DEVELOPMENT SERVICES DEPARTMENT
STAFF REPORT – TO THE DESIGN COMMISSION

Permit Number: DR-2024-0005

Project Components: Design Review for construction of 208 apartment units.
Development will include on-site parking lot, creation of on-street parking stalls, public mid block connectors, open space, utilities, plaza and landscaping.

Date of Meeting: May 8th, 2024

① ELEVATION: CITY BUILDINGS (A&B) - PARKING SIDE
1/16" = 1'-0"

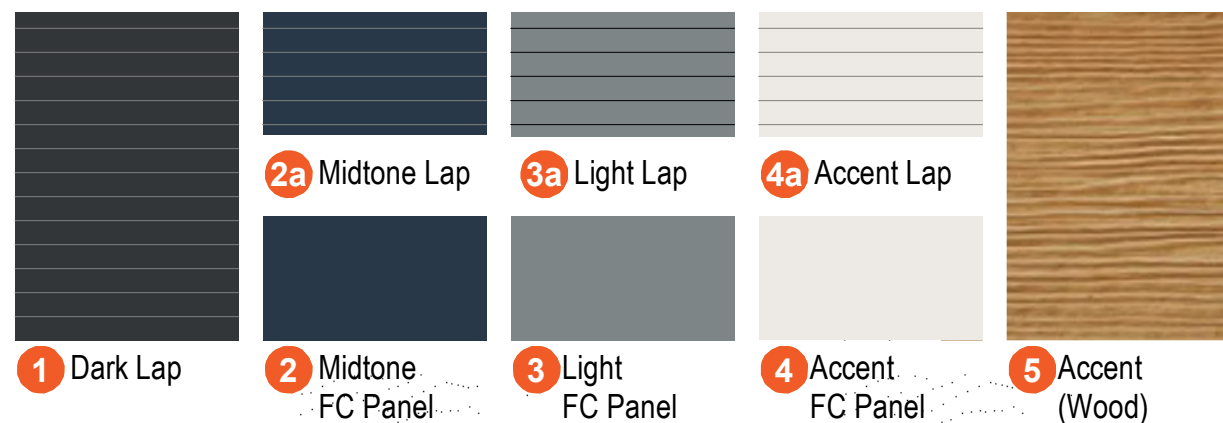
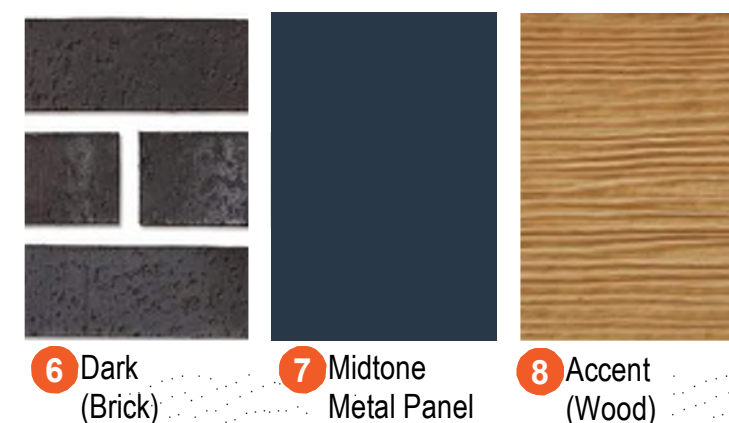
- City building exterior walls (Sheet D23) these façades includes an overall well designed façade with articulation throughout. Staff does feel that some additional color changes could be beneficial between the blue sections to differentiate between the horizontal lap siding and the panels and or vertical use of the wood material similar to the other side of this building. Additionally, a roofline break in the blue sections would also create a more modulation roofline as discussed in other areas of the report.

- A. Sheet D23 notch or recess section of roofline between the two 35' segments.
 - B. Sheet D24 notch or recess section of roofline between the two 35' segments.

1 ELEVATION: CITY BUILDINGS (A&B) - PLAZA SIDE
1/16" = 1'-0"

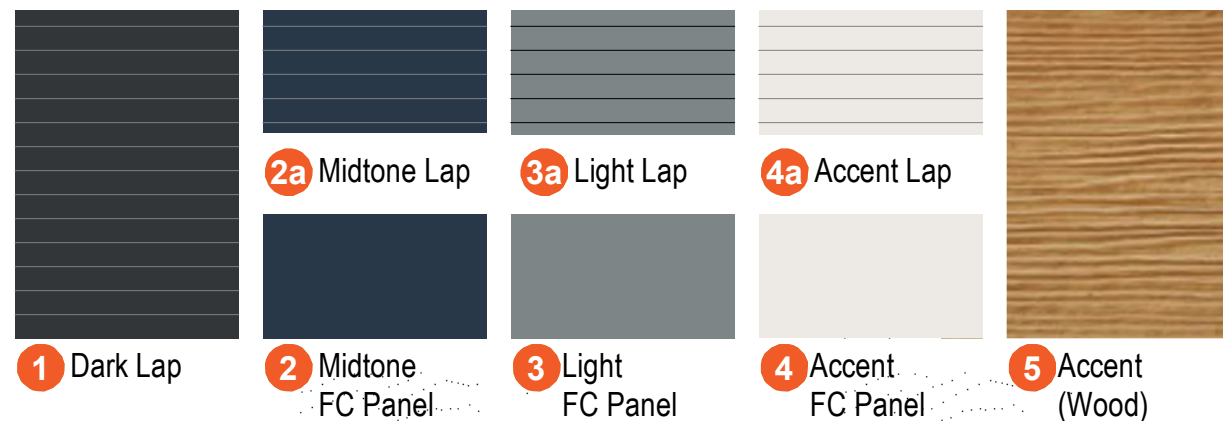
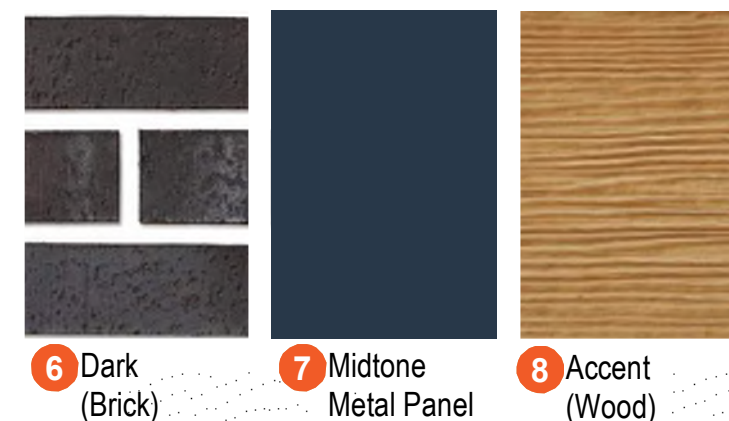
- City building interior walls (Sheet D24) these façades includes a similar feel as the opposite side of the building except that this elevation includes additional material changes around the stairs and windows.

① ELEVATION: PERIMETER BUILDINGS (CEFH) - COURTYARD SIDE
1/16" = 1'-0"

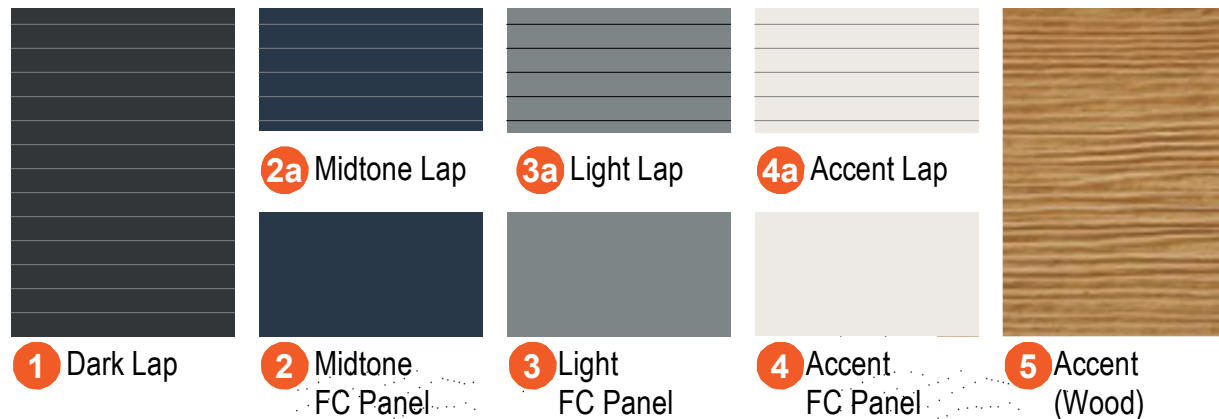
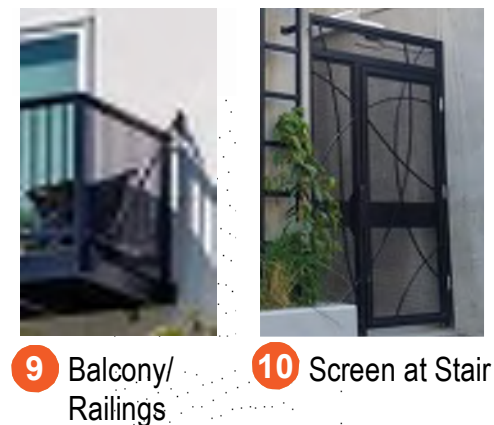
- Perimeter buildings courtyard elevations (Sheet D26) these façades includes a similar feel as other facades and is one of the least visible sections of any of the elevations. This elevation uses primarily horizontal and panel siding with some accent wood around the stairs. Given the smaller façade size and limited visibility, staff doesn't have any proposed changes here.

① ELEVATION: PERIMETER BUILDINGS (CEFH) - PARKING SIDE
1/16" = 1'-0"

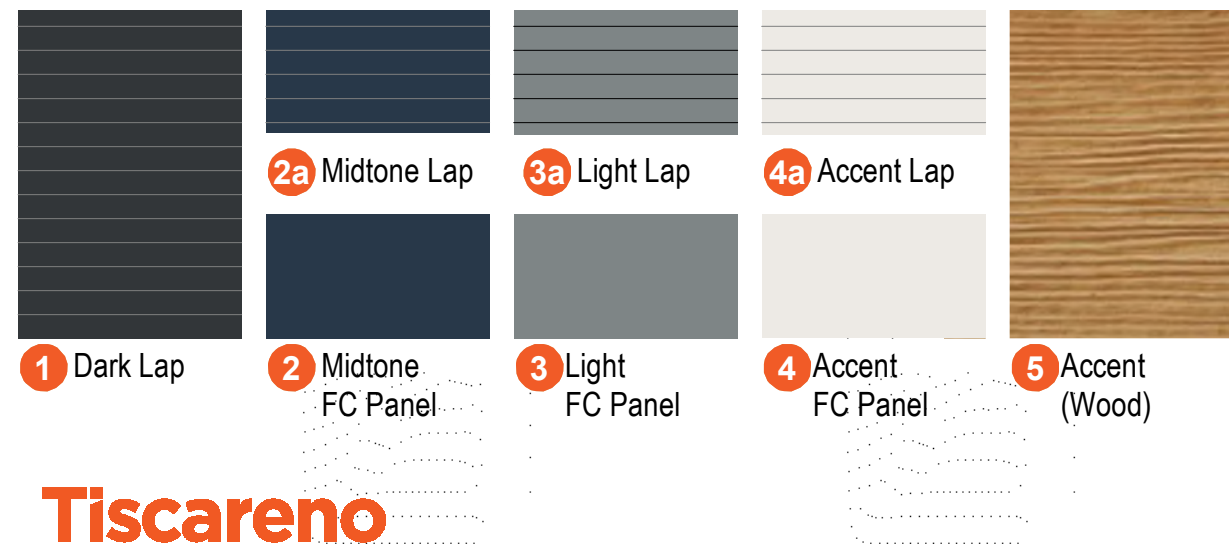
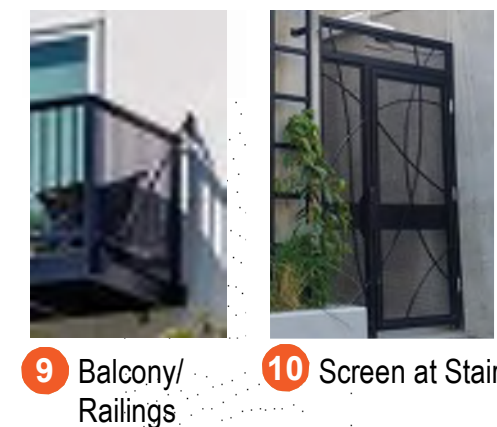
- Perimeter buildings parking elevations (Sheet D27) these facades do face outwards and include a very well broken up elevation. The only recommendation staff has on these elevations are to notch or recess the middle section of roofline showing as 75' in length.

- C. Sheet D27 notch or recess the middle section of roofline showing as 75' in length.
4. **DG 2.5.2 Streetscape amenities**
Streetscape amenities listed in category II should be added along the site frontage where appropriate.

② ELEVATION: PERIMETER BUILDINGS (CEFH) - PARKING SIDE
1/16" = 1'-0"

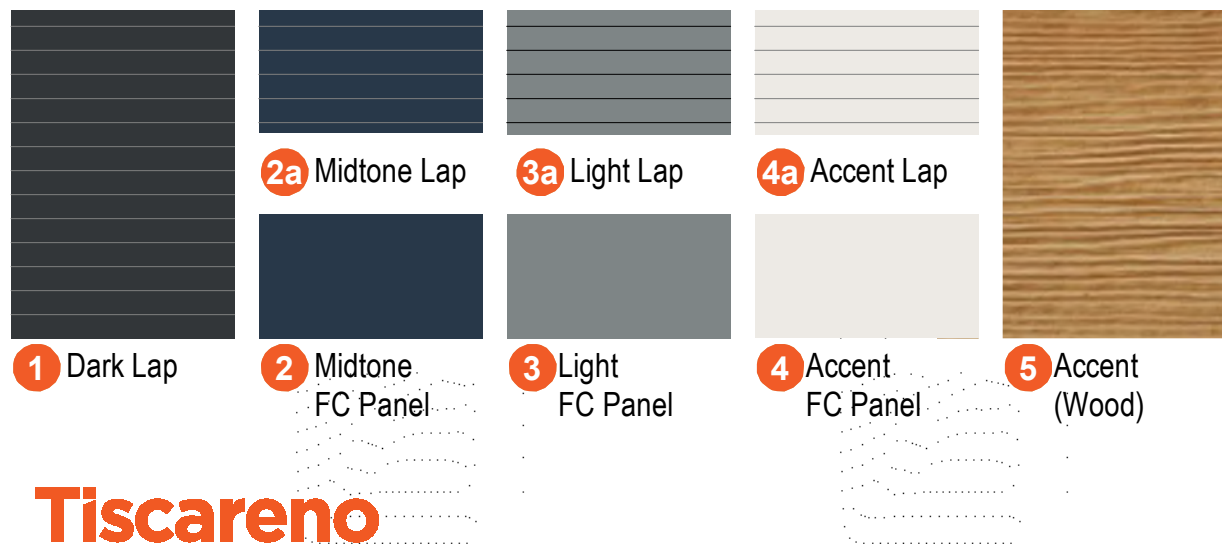
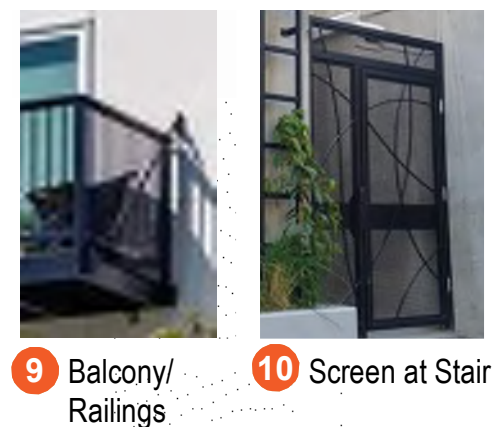
- Perimeter buildings end elevations (Sheet D28) half of these facades do face outwards and include a well broken up elevation. The only recommendation staff has on these elevations are to notch or recess a section or sections of the parking side roofline showing as 76' in length.
